COUNTY OF SAN DIEGO

DEPARTMENT OF PLANNING AND LAND USE BUILDING DIVISION

SUPPLEMENTAL CORRECTION LIST – No. 2 Non-Residential Accessibility Regulations

Parking & Passenger Drop-Off and Loading Zones

FIGURE 11B-18A-DOUBLE PARKING STALLS

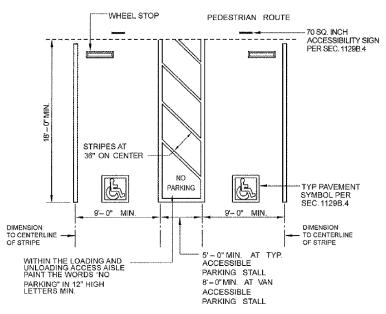
b.) By outlining or profile view of a wheelchair with occupant in white on blue background. The profile view shall be located so that it is visible to a traffic enforcement officer when a vehicle is properly parked in the space and shall be 36 inches high by 36 inches wide. See Figures 11B-18A through 11B-18C.
